Engineering Department Memorandum

To : Jeffrey W. Retzlaff, AICP, Planning Director/Zoning Administrator
From : Lawrence Ratayczak, P.E., Director of Public Works
Date : November 2, 2021
Re : Enercon Site Development – Phase 2

Waste Water Utility Comments:

SITE UTILITY PLAN

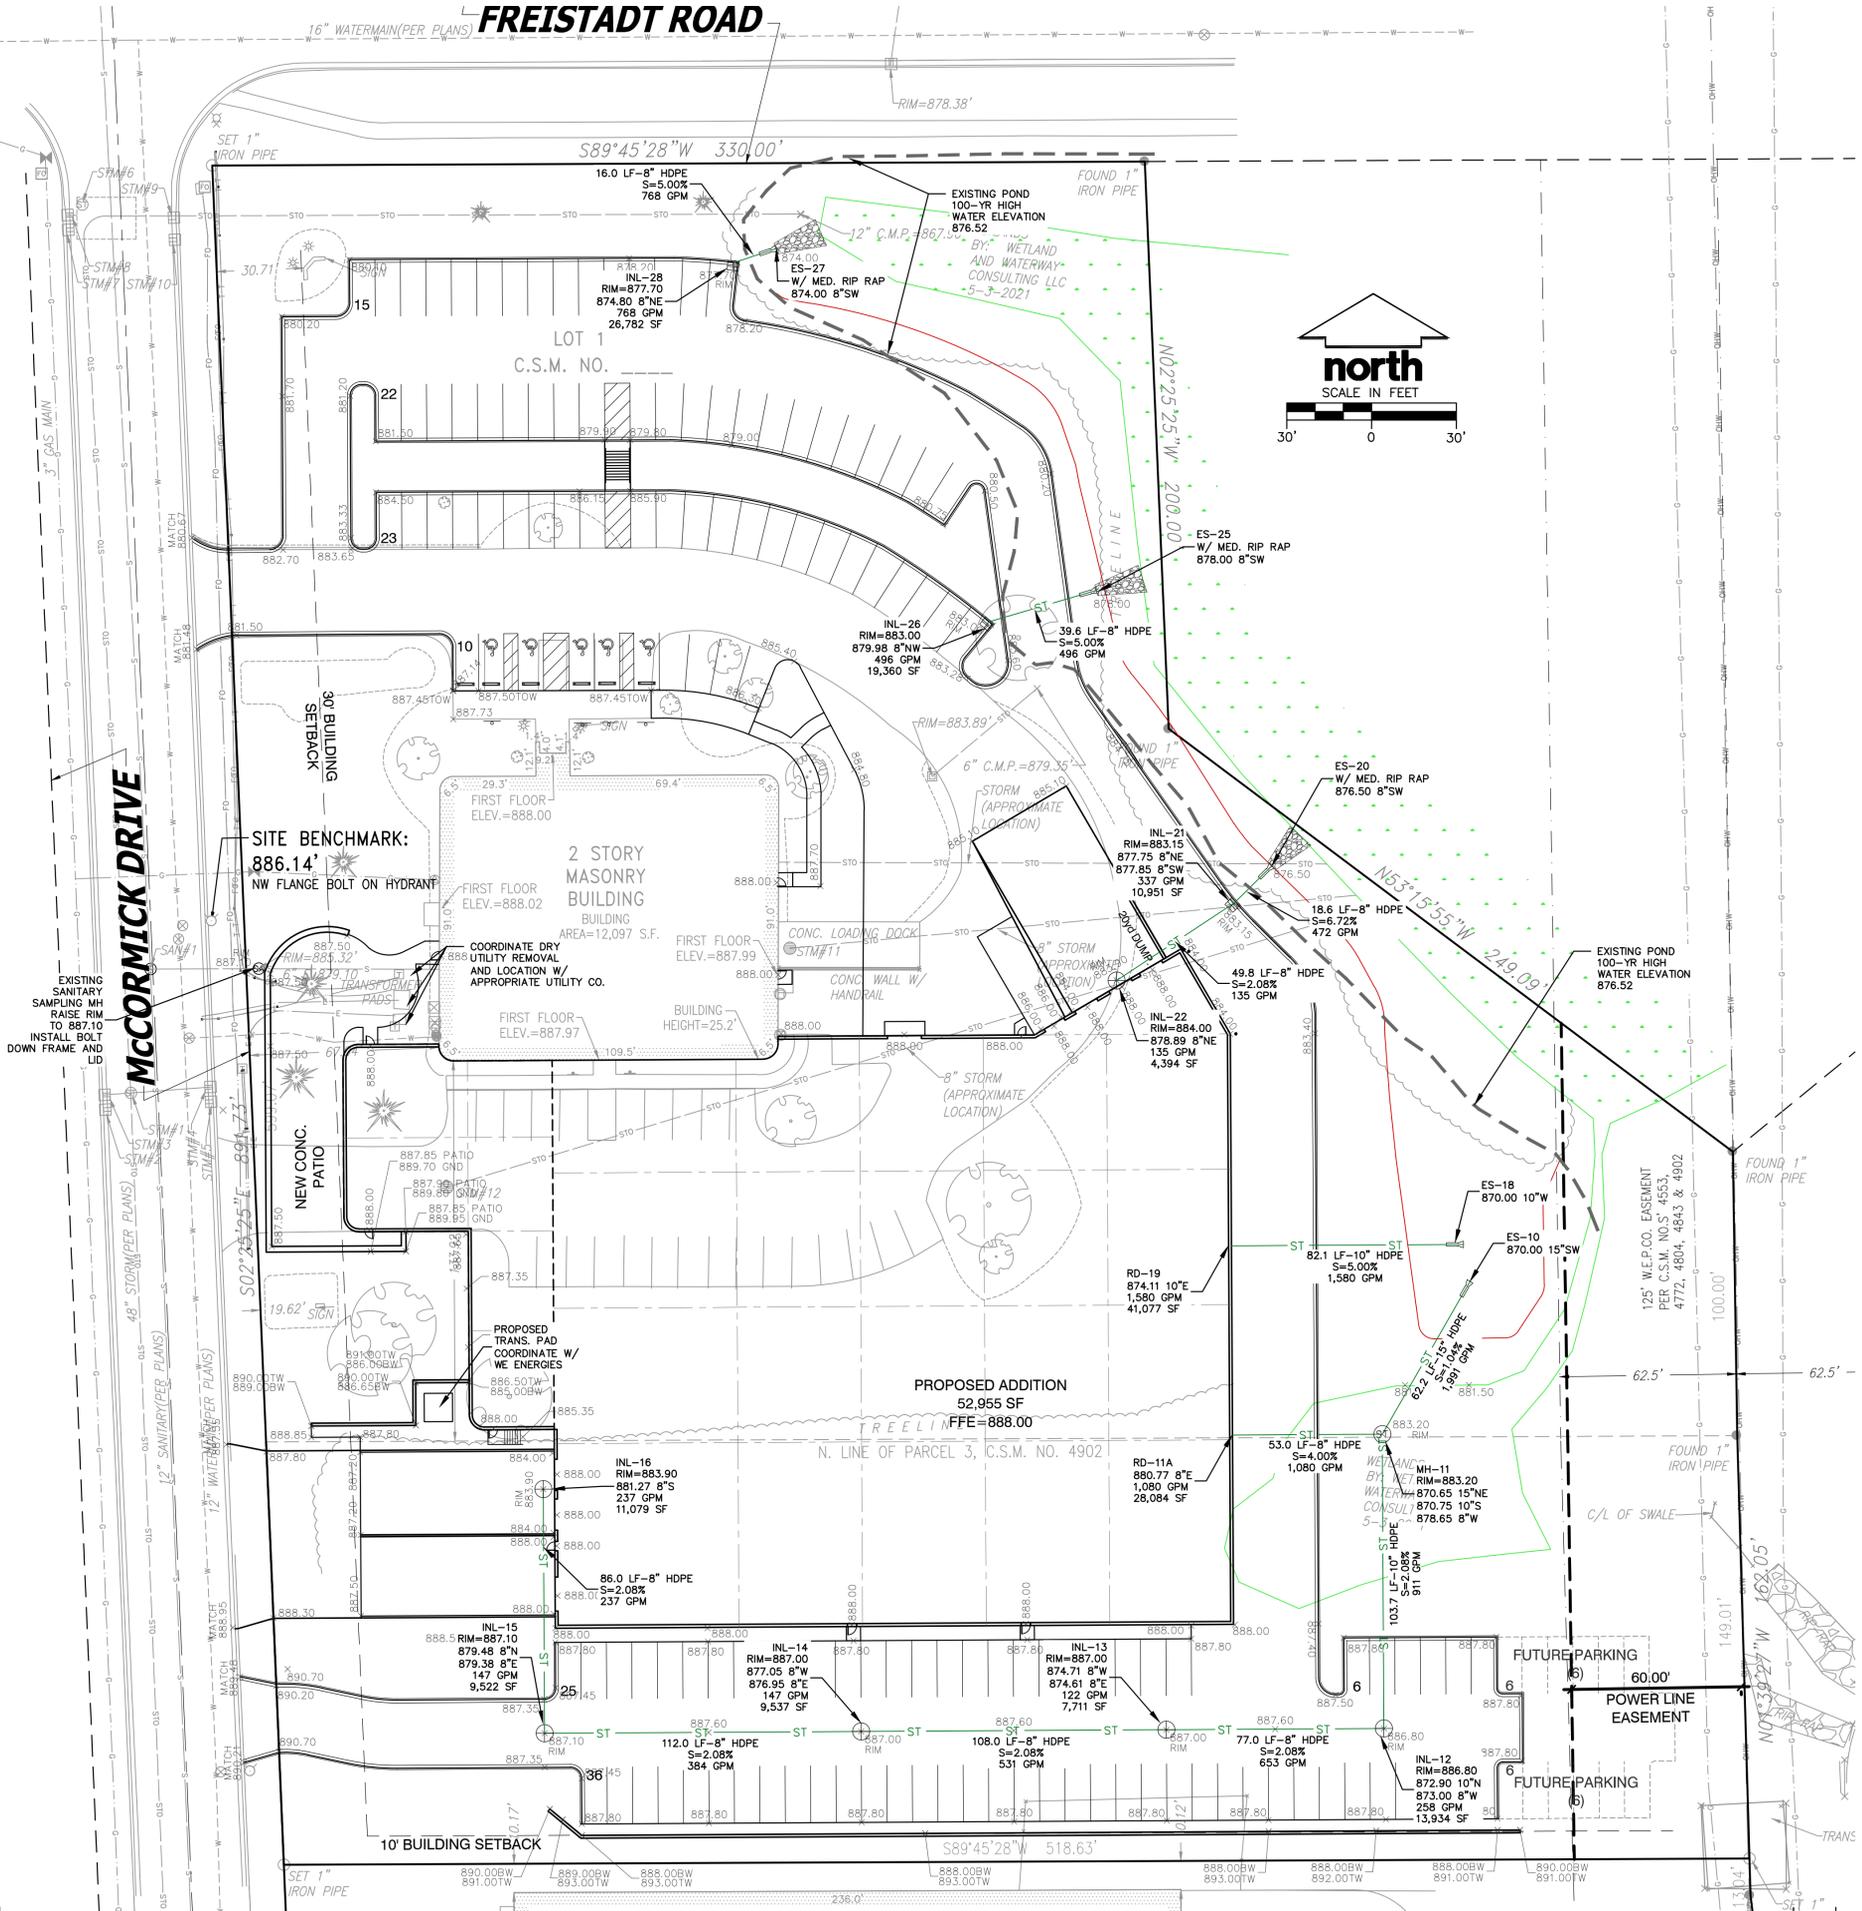
1. Please show sanitary detail and manhole chimney detail on plans.
